SUBJECT: ISSUANCE OF AMENDMENT (TAC NO. 64197)

Amendment No. 84
License No. DPR-67

ATTACHMENT TO LICENSE AMENDMENT NO. 84
TO FACILITY OPERATING LICENSE NO. DPR-67
DOCKET NO. 50-335

SAFETY EVALUATION BY THE OFFICE OF NUCLEAR REACTOR REGULATION

FIGURE 3.2-1
ALLOWABLE PEAK LINEAR HEAT RATE VS. BURNUP

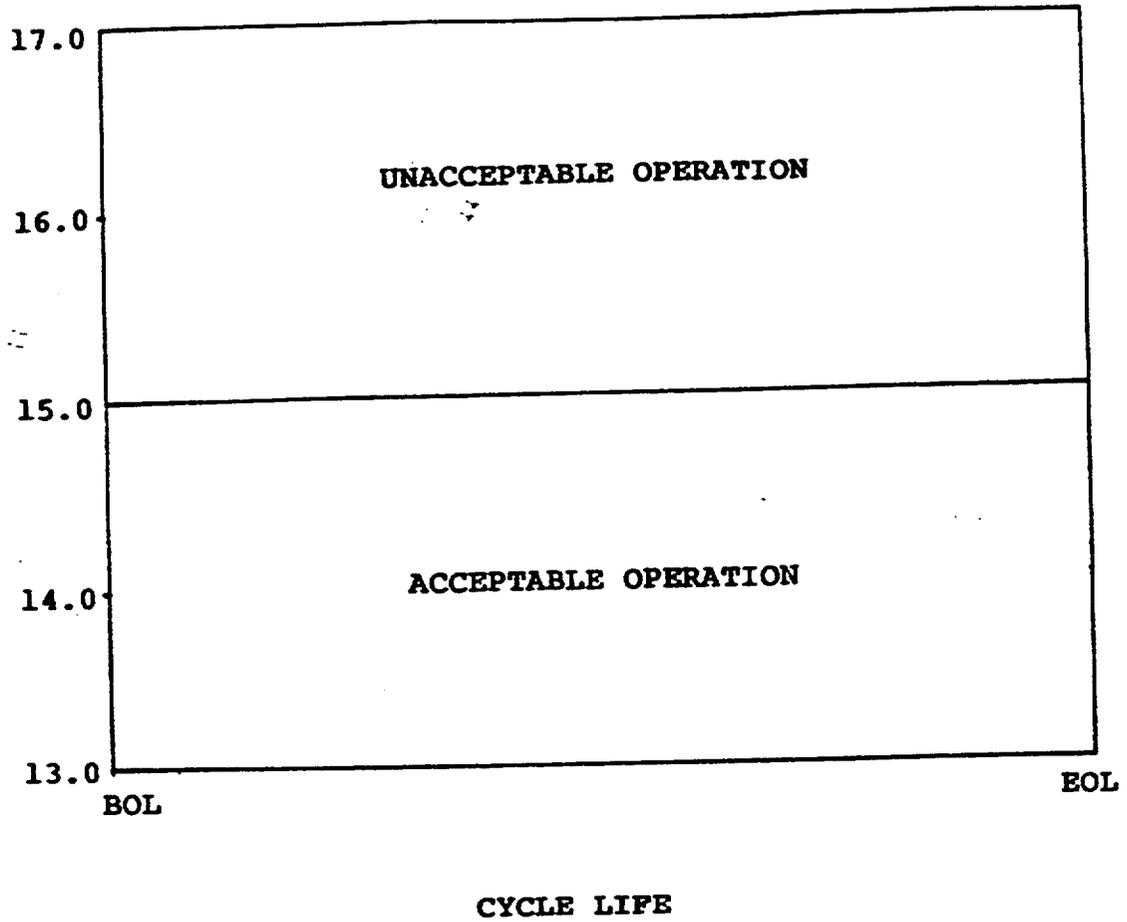
This amendment permits the allowable peak linear heat rate to be 15 kw/ft for all axial fuel elevations for all times in core life.

By letter L-86-522 dated December 23, 1986, Florida Power and Light Company (FPL) submitted a request to change the allowable peak linear heat rate (LHR) of St. Lucie Unit 1 Technical Specification 3.2.1, Figure 3.2.1, Allowable Peak Linear Heat Rate vs. Burnup, to 15 kw/ft, independent of core height and exposure and valid up to a steam generator tube plugging level of 15%. The current LHR limits are 15 kw/ft up to a relative core height of 0.6, then decreasing linearly to 14 kw/ft at a relative core height of 0.81 and 10.81 kw/ft at a relative core height of 1.0. These current limits are valid up to a steam generator tube plugging level of 11%. In order to support this change, FPL also submitted a revised LOCA-ECCS analysis, XN-NF-86-137, "St. Lucie Unit 1 LOCA-ECCS Analysis with 15% Steam Generator Tube Plugging" (Ref. 1).

The staff has reviewed the proposed change to St. Lucie Unit 1 Technical Specification 3.2.1 for increasing the allowable peak LHR to 15 kw/ft for all axial elevations for all times in core life and finds it acceptable. Included in the review were changes to the previous LOCA analysis consisting of an increase in the steam generator tube plugging limit to 15%, use of the FCTF reflood correlations, and use of less conservative, though still bounding, combinations of stored energy and axial power shapes. Asymmetric tube plugging was modeled with the broken loop steam generator having 17% of its tubes plugged and the steam generator in the intact loop having 13% of its tubes plugged. The LOCA analysis performed with these changes showed that the acceptance criteria presented in 10 CFR 50.46 are satisfied.
